ENERGY GATEWAY SOUTH TRANSMISSION PROJECT

Revised Standard Form 299 Right-of-Way Application Attachment A

**Revised from
October 2010
Submittal**

January 2013

Figure 7 - Proposed W125 Reroute

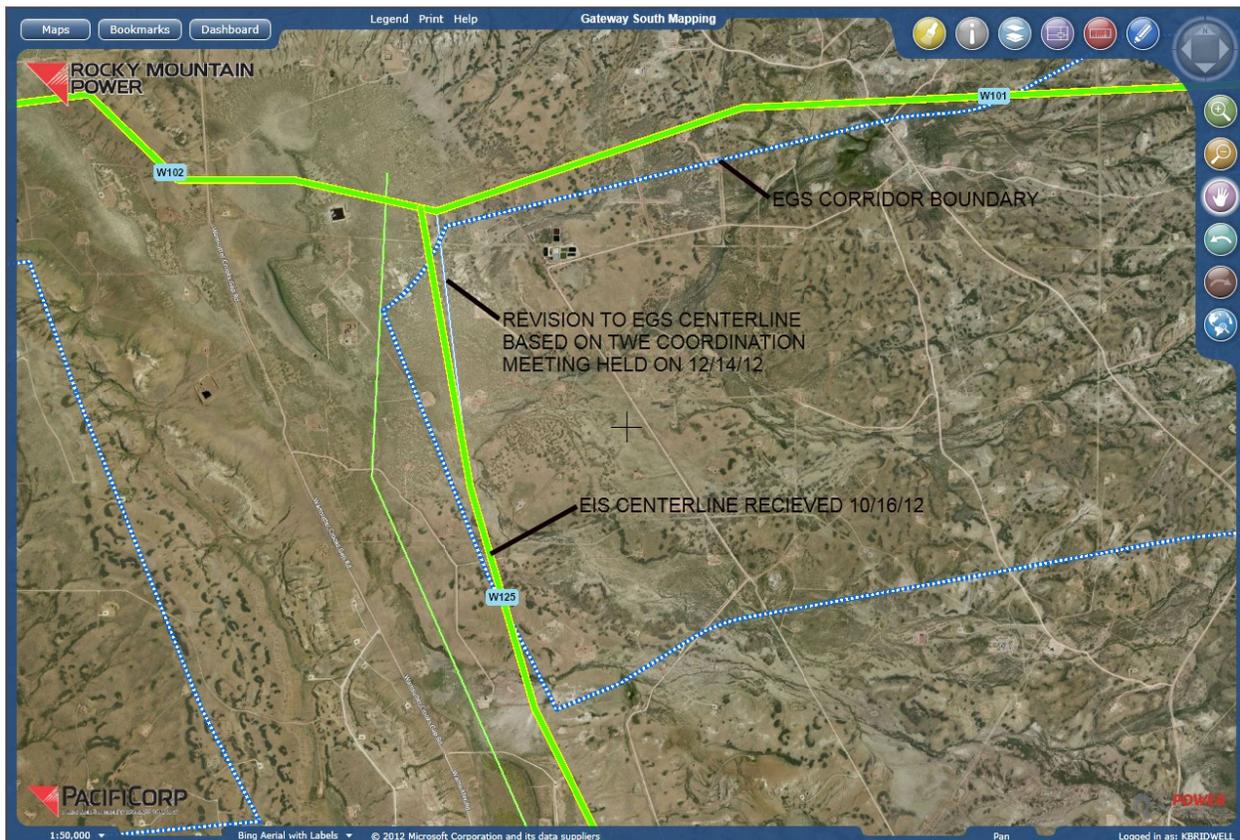
Based on coordination with future transmission lines in or near the project area, PacifiCorp/Rocky Mountain Power proposes an additional adjustment to Link W125 depicted in Figure 1. This change moves the alignment outside the current study corridor. Adjusting W125 alignment allows adequate separation from other future planned transmission line routing....See Figure 7 for a depiction of the proposed adjustment.
